Access Compliance Report

Public Rights-of-Way

(Curb Ramps)

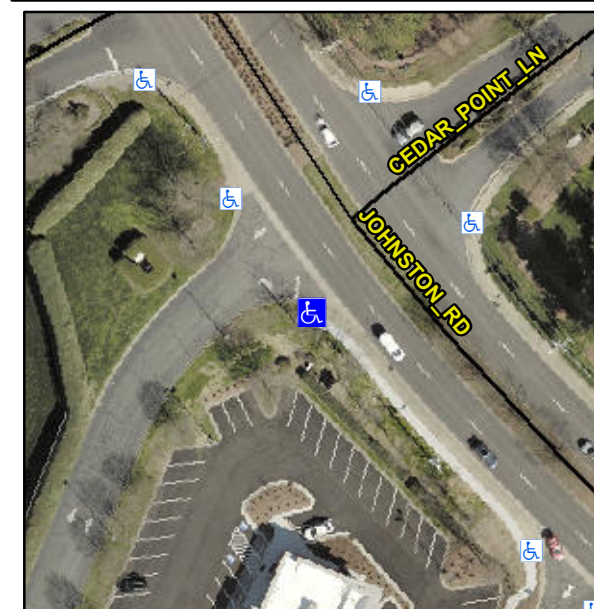
Intersection ID: 25287	Main Street: CEDAR_POINT_LN	Cross Street: JOHNSTON_RD	Location: SW
ADA ID: 38B1E429A6DF	Ramp Type: Perp	Initial Pass/Fail: Fail	Overall Compliance: No
Severity Score: 12.5			
Codes/Mitigation Info/Possible Solution		Field Measurements/Component Compliance

R304.2.2

Compliance	Description	Data	Compliance	Description	Data
N/A	Ramp Length (in)	59.0	No	Ramp Slope (%)	8.8
Yes	Ramp Width (in)	48.0	Yes	Ramp XSlope (%)	1.2
N/A	Flare Type LT	N/A	N/A	Flare Type RT	N/A
N/A	Flare Slope LT (%)	N/A	N/A	Flare Slope RT (%)	N/A
N/A	Flare Traversable LT?	N/A	N/A	Flare Traversable RT?	N/A
N/A	Landing Length (in)	N/A	N/A	DWS Provided?	N/A
N/A	Landing Width (in)	N/A	N/A	DWS Contrast?	N/A
N/A	Landing Slope (%)	N/A	N/A	DWS Length (in)	N/A
N/A	Landing X Slope (%)	N/A	N/A	DWS Full Width?	N/A
N/A	Landing Curb? (Y/N)	N/A	N/A	DWS Offset (in)	N/A
N/A	Shared Landing?	N/A			
N/A	Gutter Ponding?	N/A	N/A	Gutter Slope (%)	N/A
N/A	Gutter Lip Ht (in)	N/A	N/A	Gutter X Slope (%)	N/A
N/A	Painted X Walk1?	No	N/A	Painted X Walk2?	N/A
	X Walk 1 Direction	To NW		X Walk 2 Direction	N/A
N/A	X Walk 1 Width (in)	N/A	N/A	X Walk 2 Width (in)	N/A
	X Walk 1 Slope (%)	0.2		X Walk 2 Slope (%)	N/A
	X Walk 1 X Slope (%)	1.8		X Walk 2 X Slope (%)	N/A

Remove & Replace Entire Ramp.

\$ 1850.00
